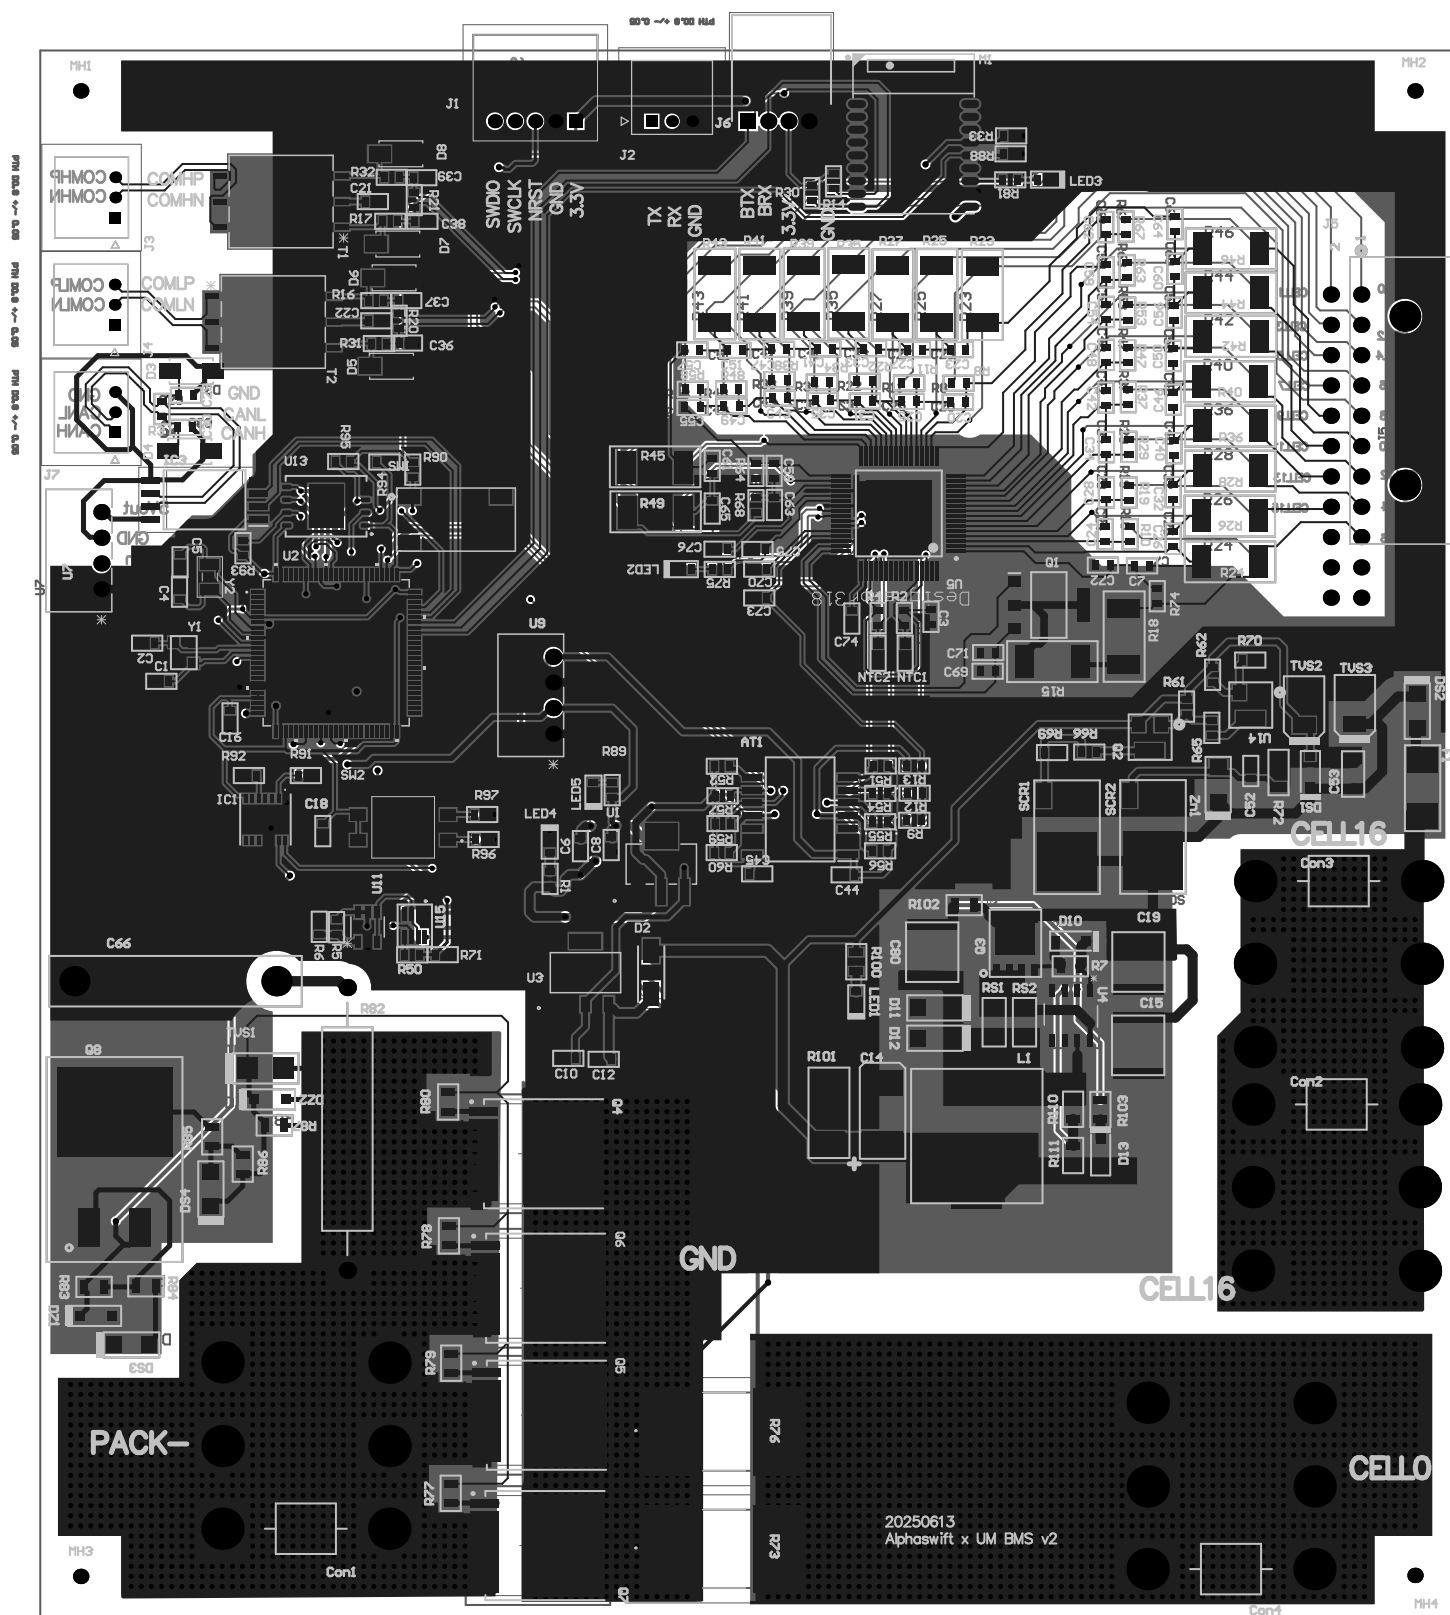
TVSDiode 18A should become TVS unidirect SMAJ12A
because of smaller gain, Q2

ZenerDiode brt52c18 should become TVS unidirect SMAJ12A
